S4.55 AMENDMENTS:

MOD2019/0585

PROJECT
TWO SEMI-DETACHED DWELLINGS WITH BASEMENT CARPARKING:
52 LAUDERDALE AVENUE, FAIRLIGHT, NSW
CLIENT
DAVID ALLEN & THE CASEY FAMILY TRUST

DRAWING TITLE	PROJECT		
ROOF/SITE PLAN	LAF		
SCALE	STATUS	NUMBER	REVISION
1:100 @A3	S4.55	A1.06	S4.55

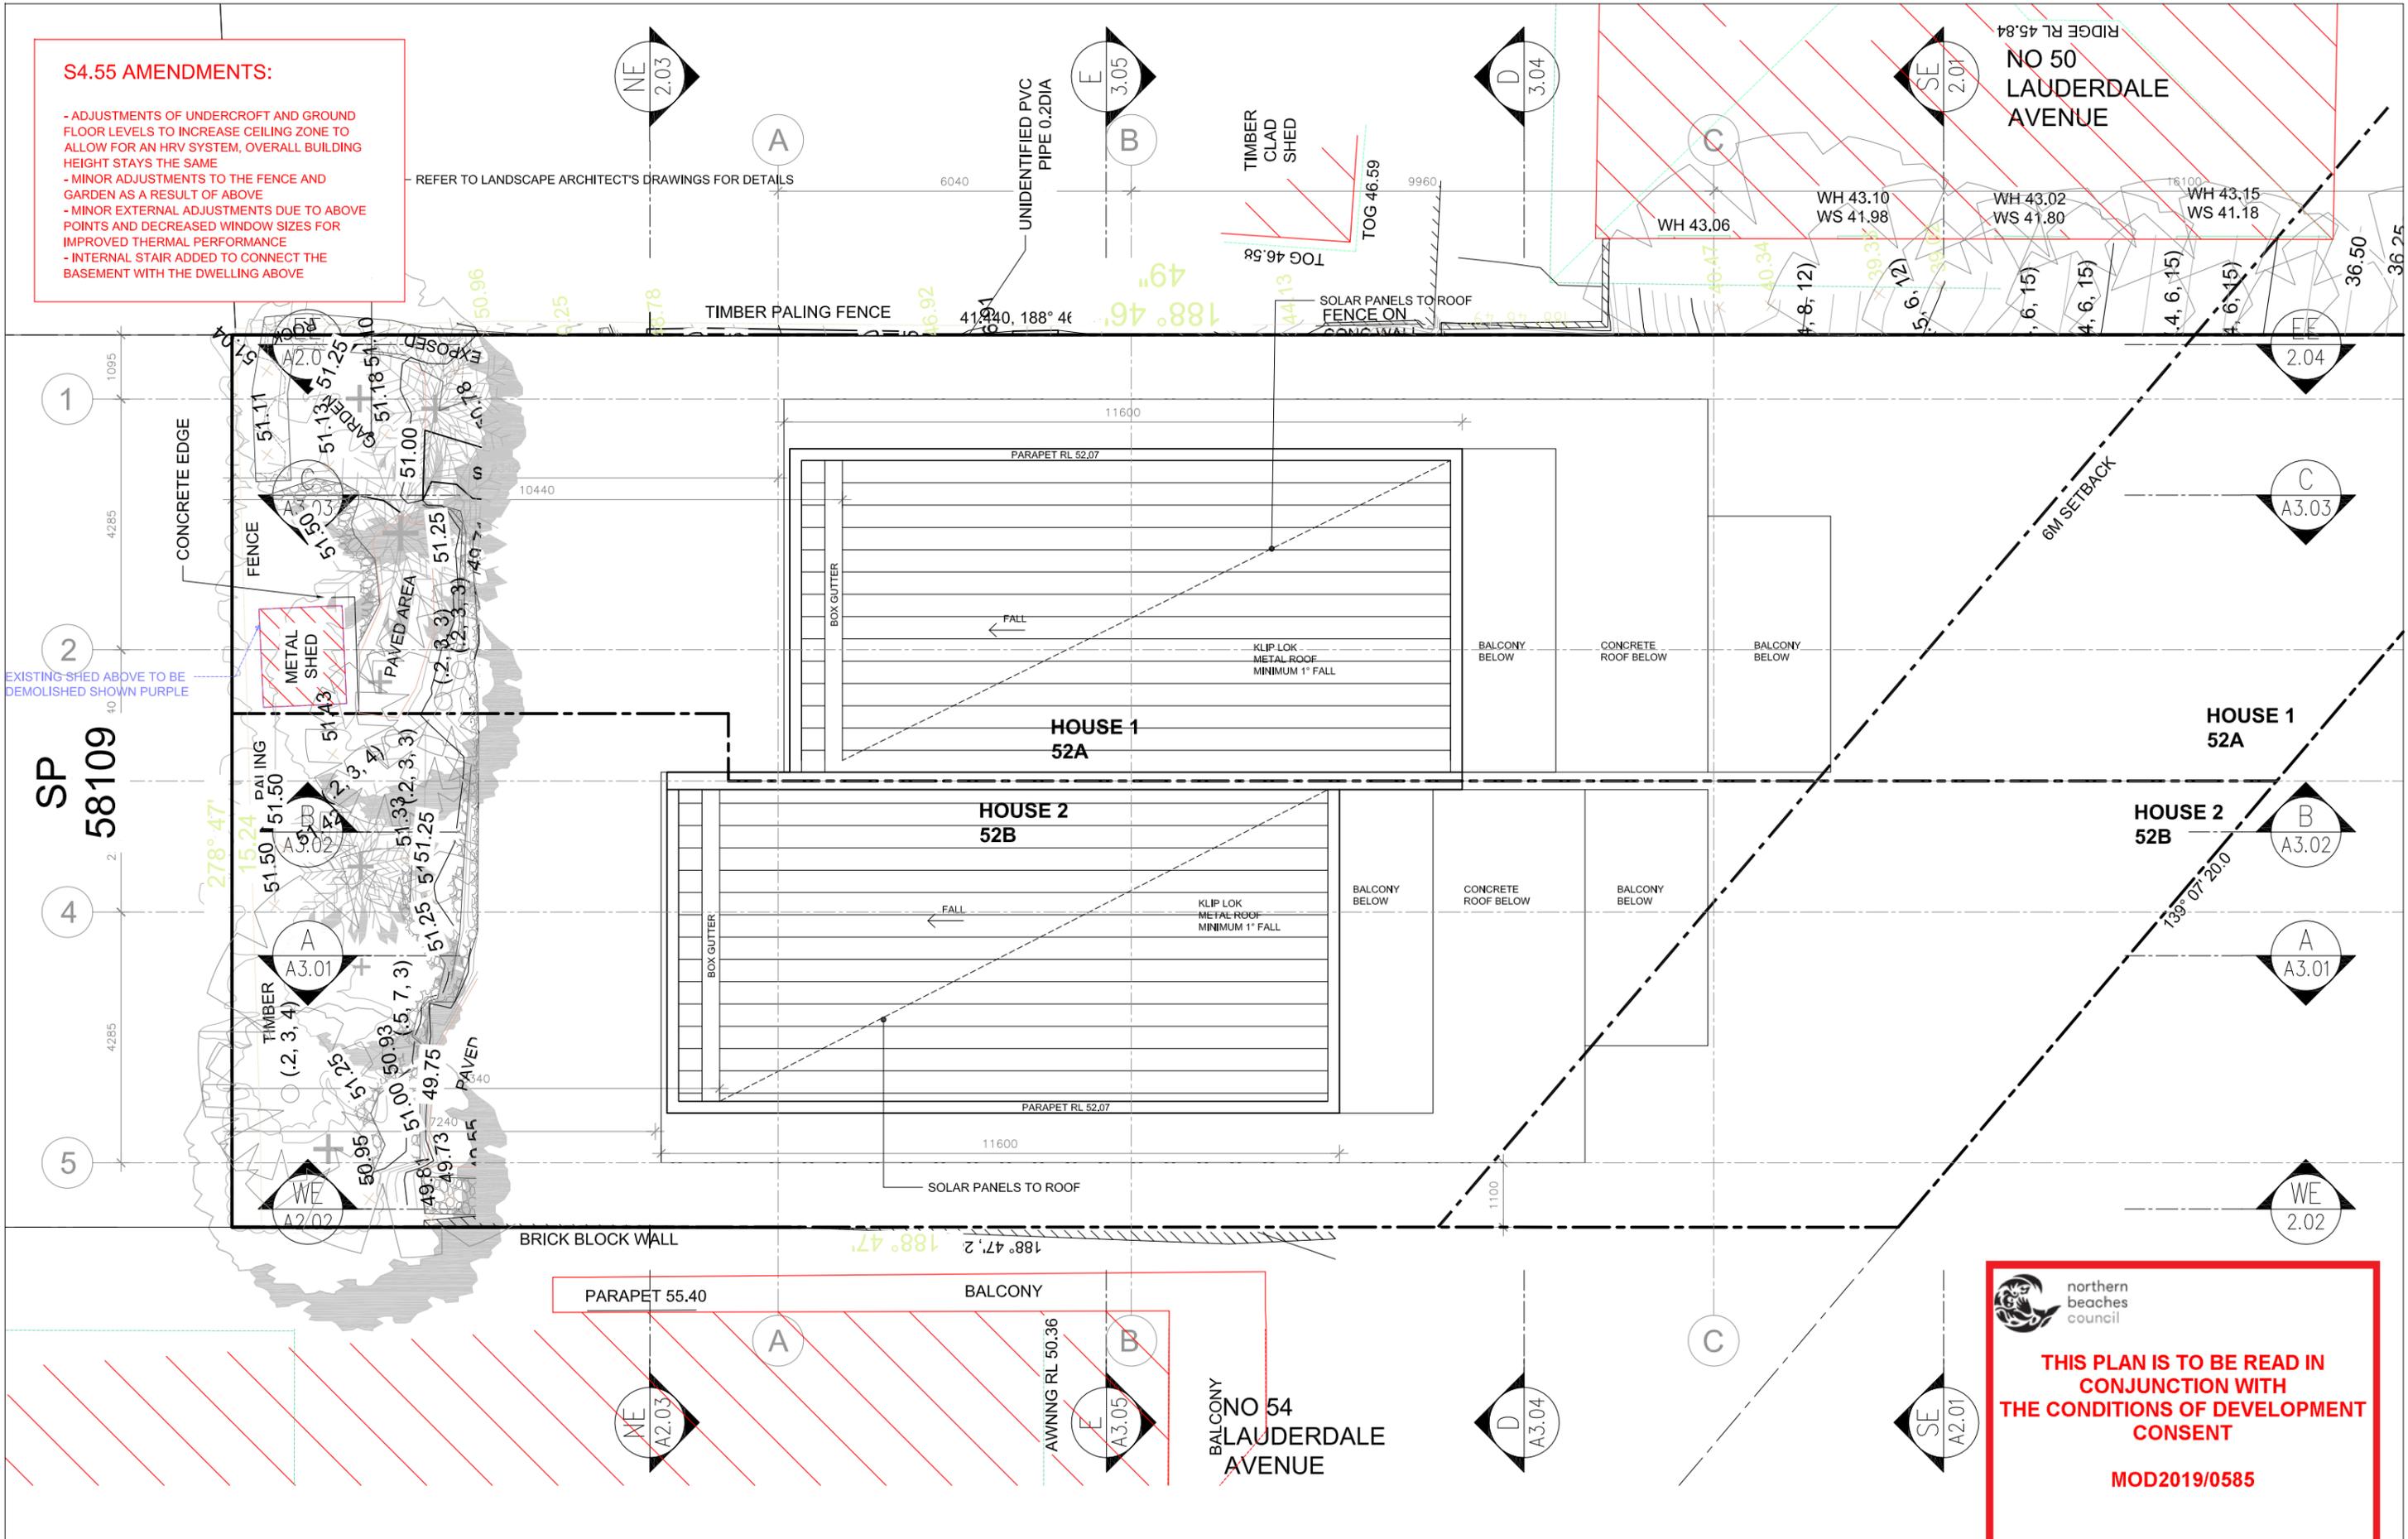
- ADJUSTMENTS OF UNDERCROFT AND GROUND FLOOR LEVELS TO INCREASE CEILING ZONE TO ALLOW FOR AN HRV SYSTEM, OVERALL BUILDING HEIGHT STAYS THE SAME
- MINOR ADJUSTMENTS TO THE FENCE AND GARDEN AS A RESULT OF ABOVE
- MINOR EXTERNAL ADJUSTMENTS DUE TO ABOVE POINTS AND DECREASED WINDOW SIZES FOR IMPROVED THERMAL PERFORMANCE
- INTERNAL STAIR ADDED TO CONNECT THE BASEMENT WITH THE DWELLING ABOVE

DRAWING TITLE	PROJECT
SOUTH ELEVATION	LAF
SCALE	REVISION
1:100 @A3	S4.55
STATUS	NUMBER
s4.55	A2.01

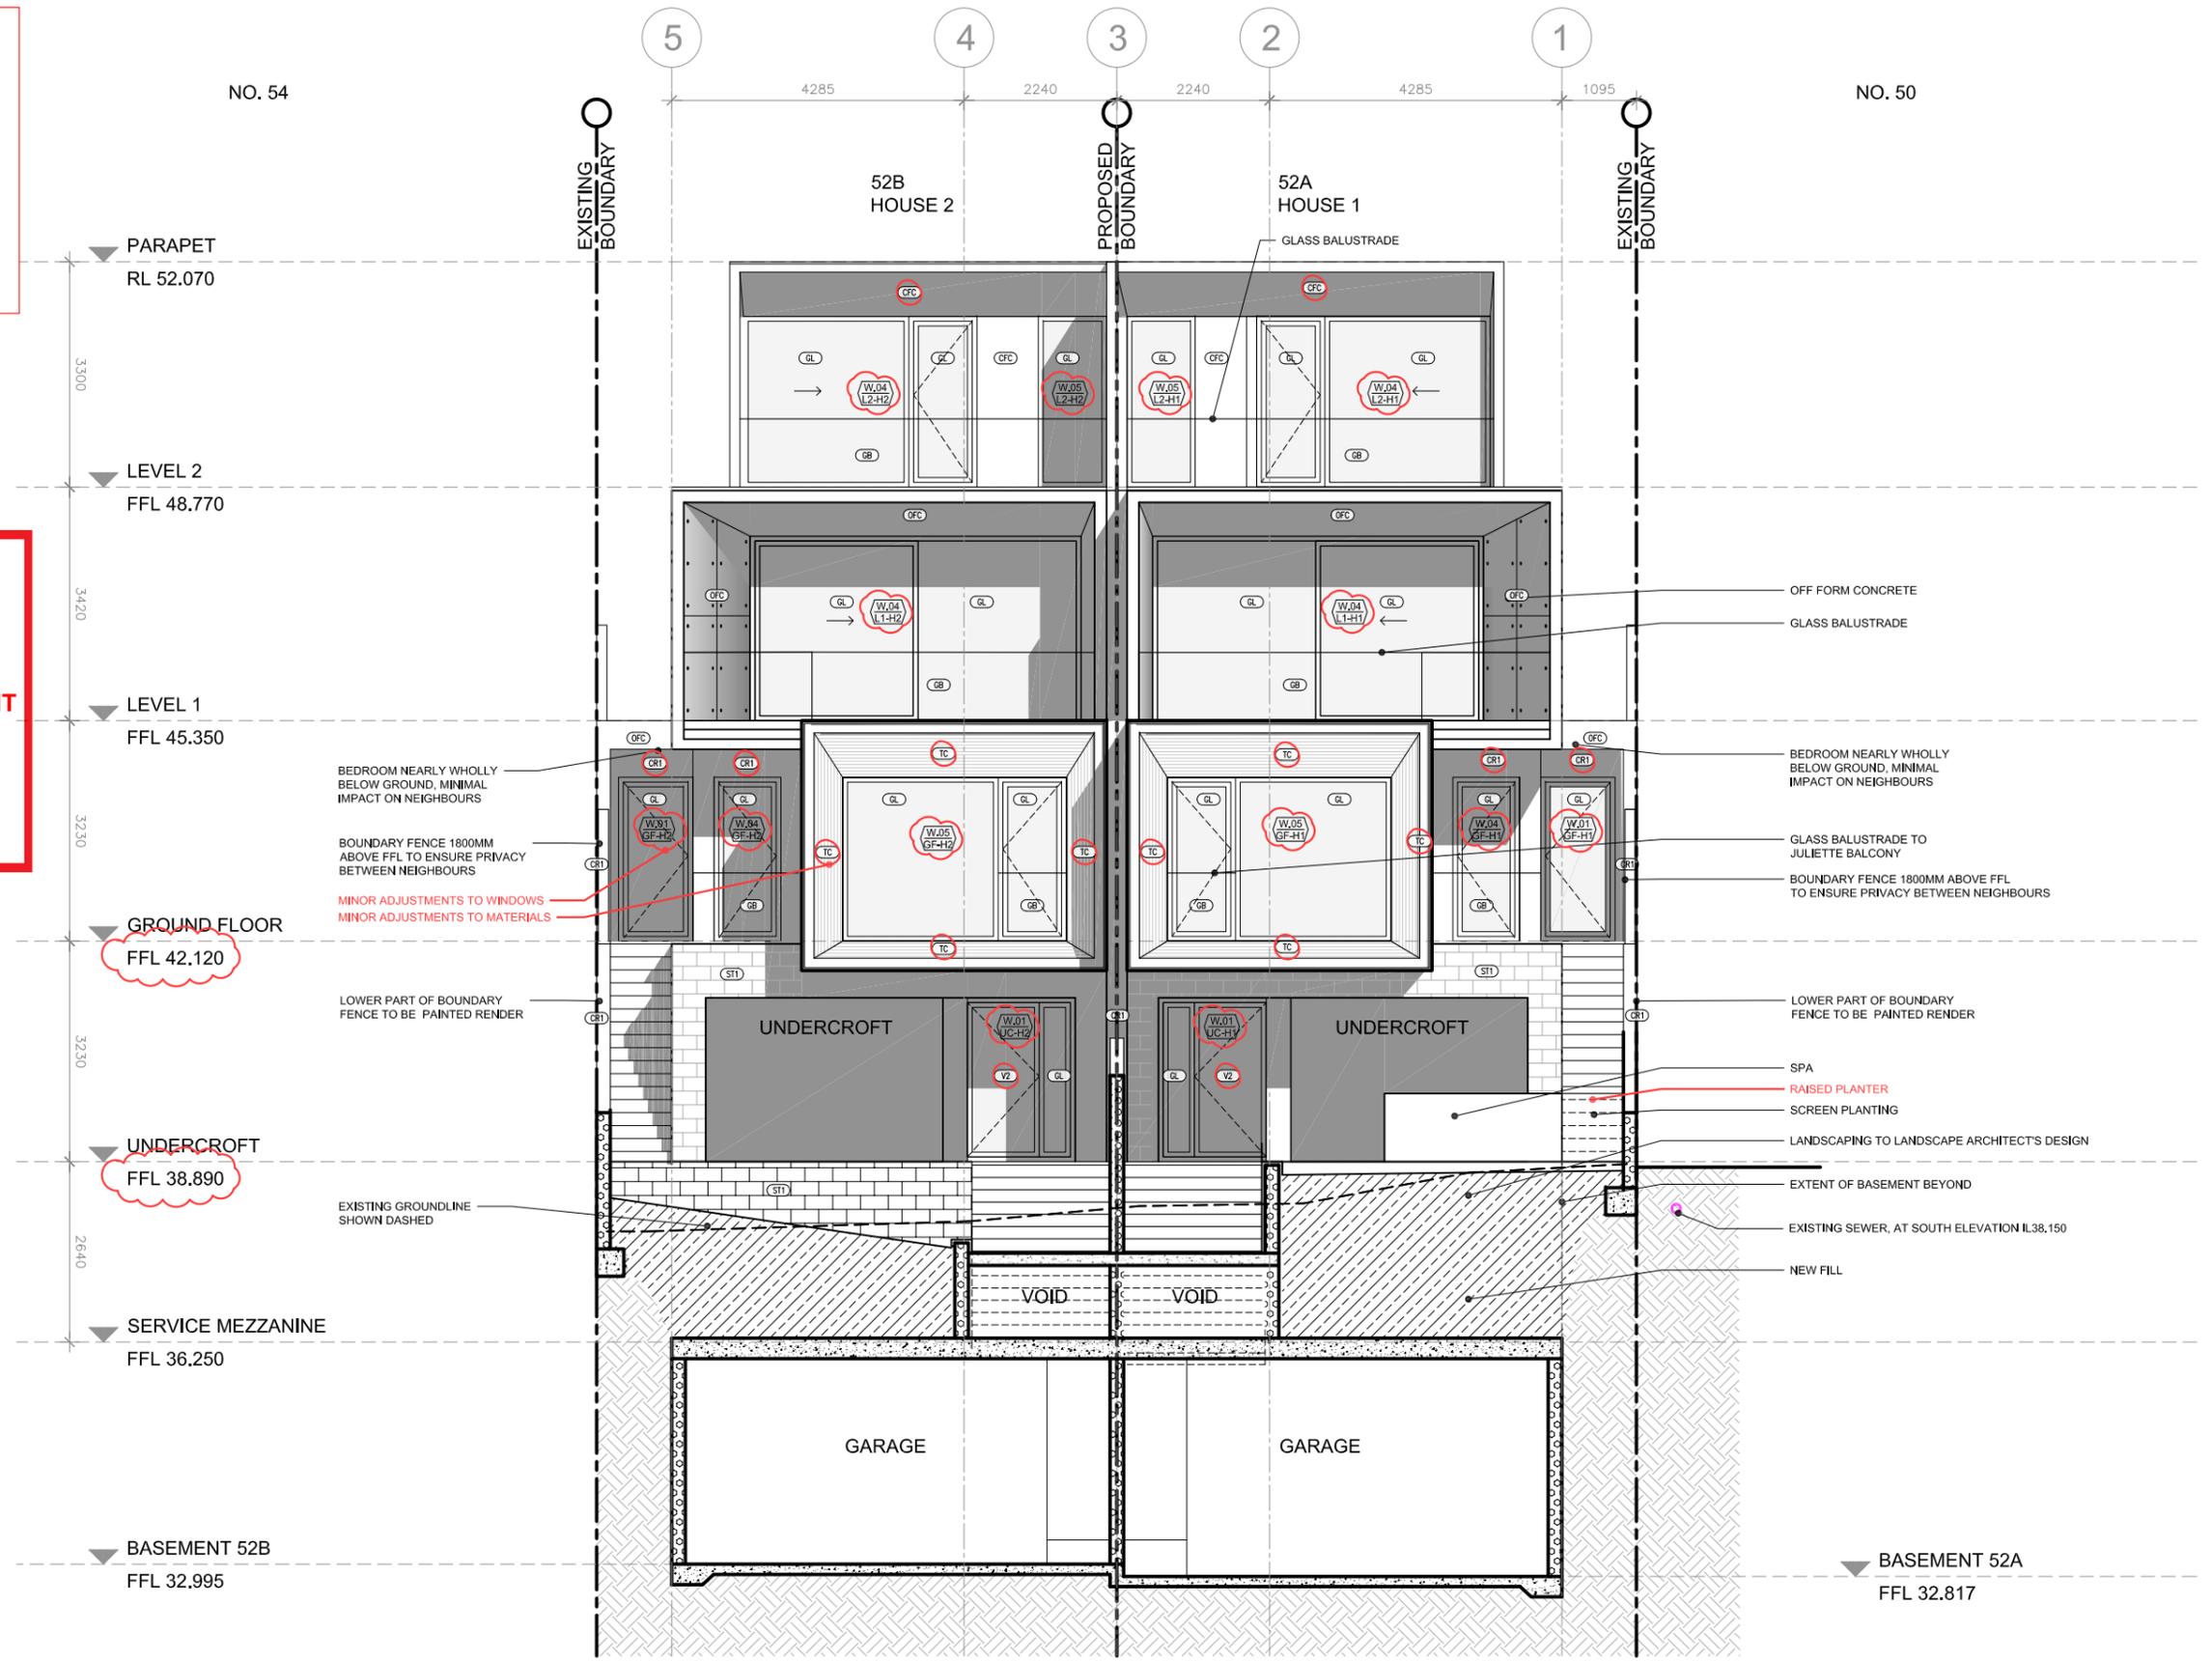
- ADJUSTMENTS OF UNDERCROFT AND GROUND FLOOR LEVELS TO INCREASE CEILING ZONE TO ALLOW FOR AN HRV SYSTEM, OVERALL BUILDING HEIGHT STAYS THE SAME
- MINOR ADJUSTMENTS TO THE FENCE AND GARDEN AS A RESULT OF ABOVE
- MINOR EXTERNAL ADJUSTMENTS DUE TO ABOVE POINTS AND DECREASED WINDOW SIZES FOR IMPROVED THERMAL PERFORMANCE
- INTERNAL STAIR ADDED TO CONNECT THE BASEMENT WITH THE DWELLING ABOVE

DRAWING TITLE	PROJECT		
WEST ELEVATION	LAF		
SCALE	STATUS	NUMBER	REVISION
1:100 @A3	S4.55	A2.02	S4.55

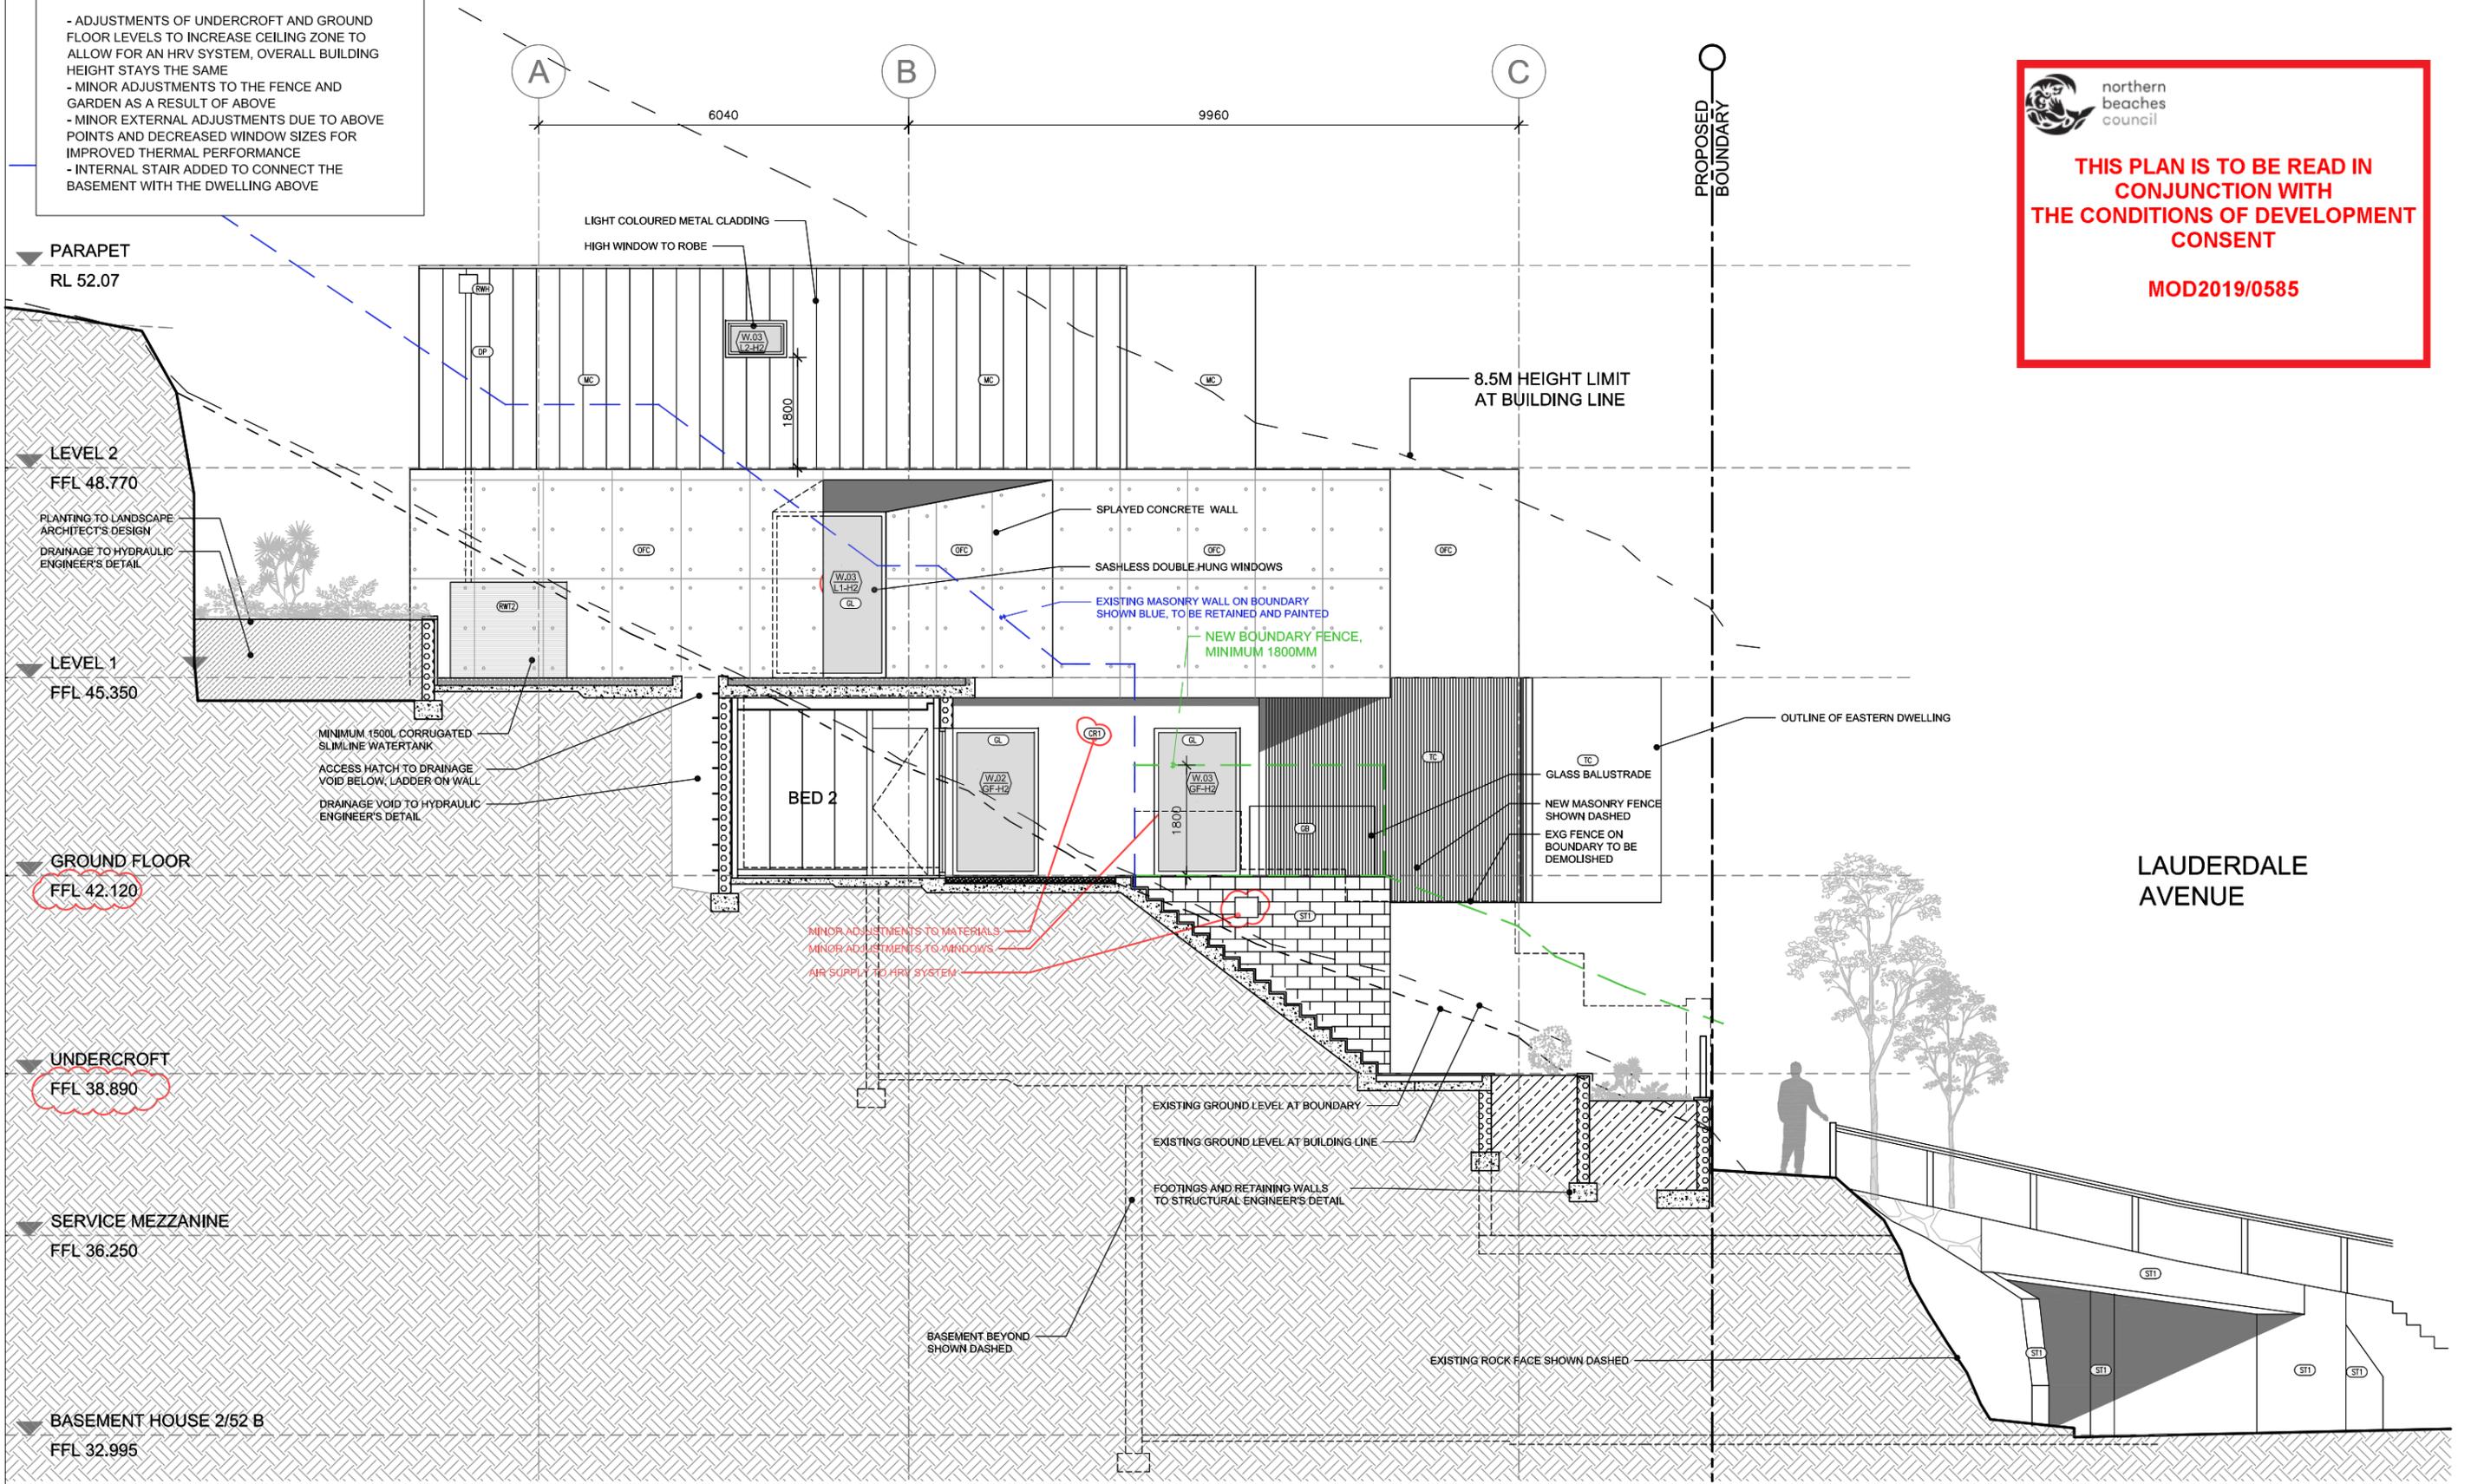
- ADJUSTMENTS OF UNDERCROFT AND GROUND FLOOR LEVELS TO INCREASE CEILING ZONE TO ALLOW FOR AN HRV SYSTEM, OVERALL BUILDING HEIGHT STAYS THE SAME
- MINOR ADJUSTMENTS TO THE FENCE AND GARDEN AS A RESULT OF ABOVE
- MINOR EXTERNAL ADJUSTMENTS DUE TO ABOVE POINTS AND DECREASED WINDOW SIZES FOR IMPROVED THERMAL PERFORMANCE
- INTERNAL STAIR ADDED TO CONNECT THE BASEMENT WITH THE DWELLING ABOVE
